31/06-07B 3714 WASHINGTON ST
Kennington Historic District

HISTORIC PRESERVATION COMMISSION

Date: July 13, 2007

SUBJECT: Historic Area Work Permit #444280, Rear Addition

1
 A1.1
 Site Plan
 1" = 20'-0"

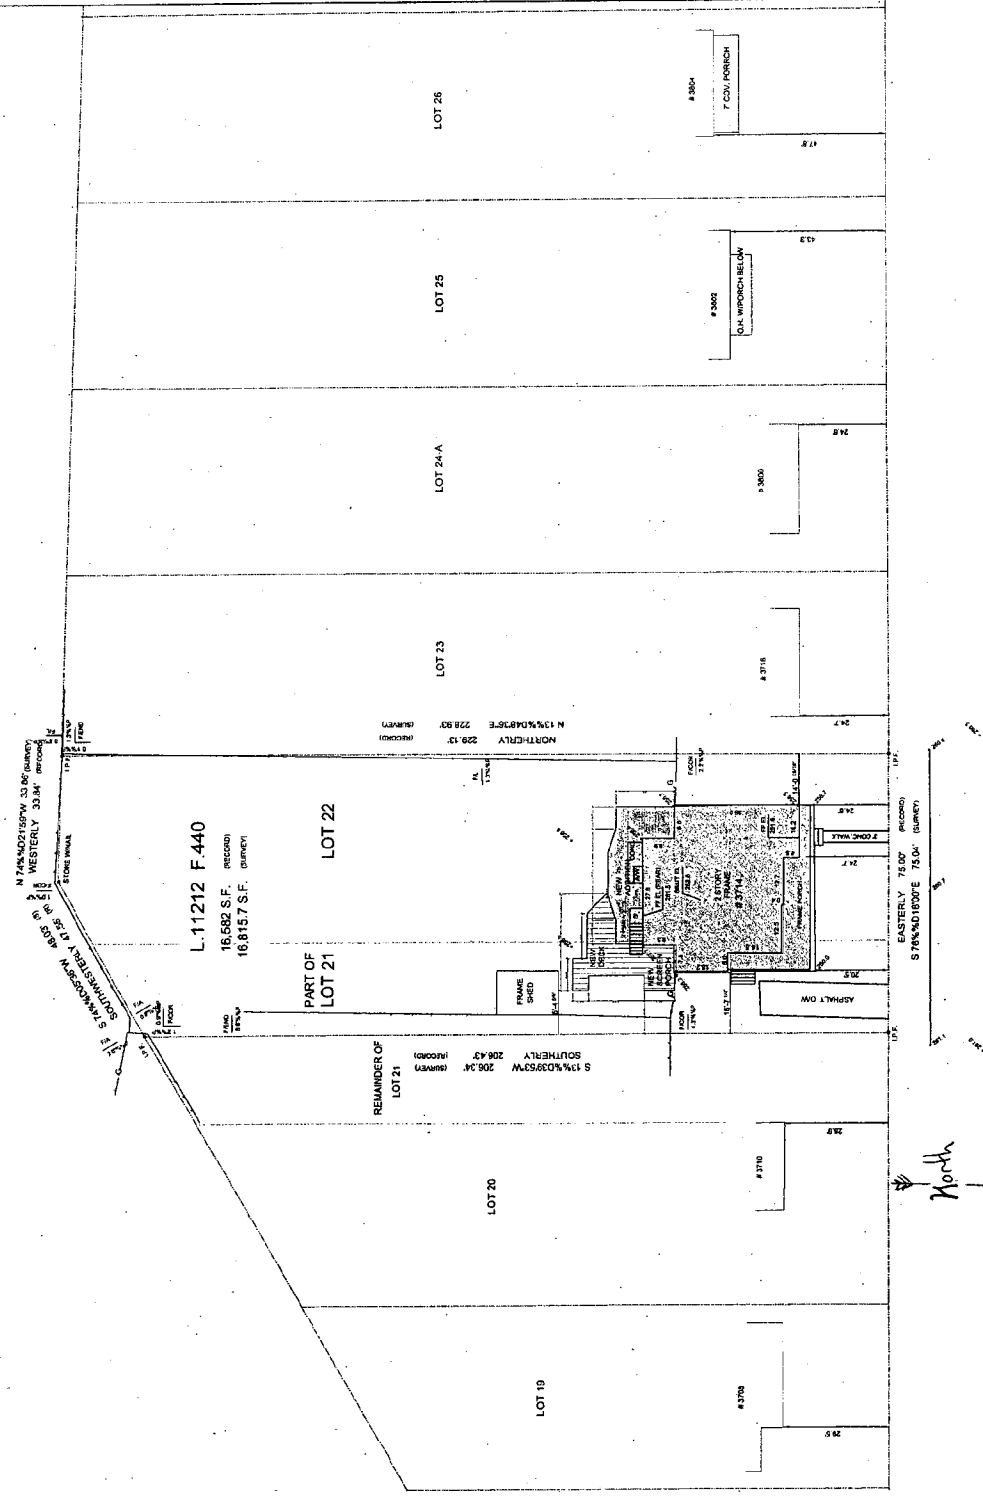
The removal of the 14" black walnut tree would not negatively impact the overall canopy of the historic district. However, it has been the Commission's policy to require the replacement of a tree for every healthy tree being removed within the historic district. As such, staff is recommending that the Commission support this tree removal with the condition that the applicant replants a new, deciduous tree (min.3" caliper) on the subject property. The tree must be selected from the Montgomery County Native species list.

East Side Elevation
1/8" = 1'-0"

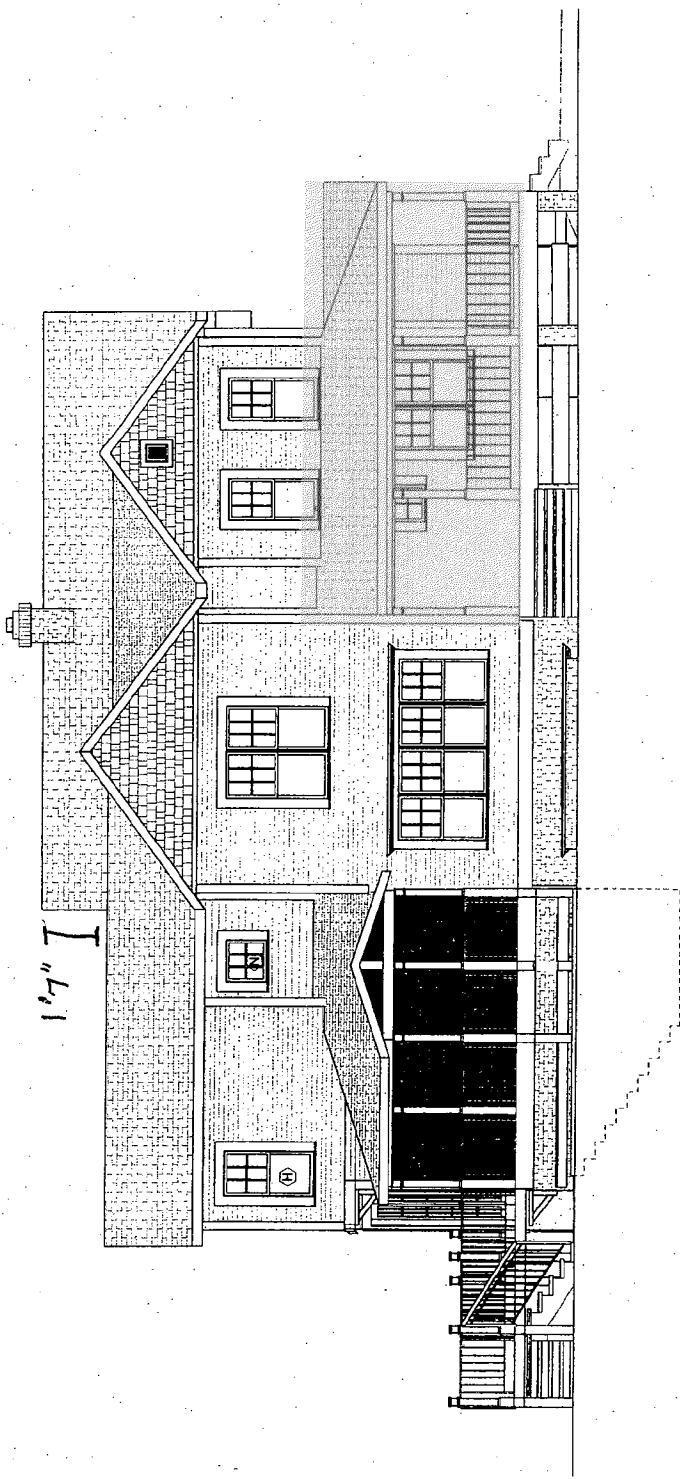
1. The proposed deck and screened porch design will be altered so they do not extend beyond the plane of the existing east (side) elevation of the house. The revised design will be reviewed and approved at a staff level.
2. One tree from Montgomery County's native species list (min. 3" caliper deciduous) will be planted on the property.

The only concern with the subject proposal is the extension of the deck and screen porch beyond the rear plane of the house. The Commission has generally made it a policy on outstanding resources within the Kensington Historic District to only support additions that do not extend beyond the existing side elevations of the house. Although the proposed screen porch and deck protrusion are complementary in style, staff feels that they compete with the already much altered principal façade of the house.
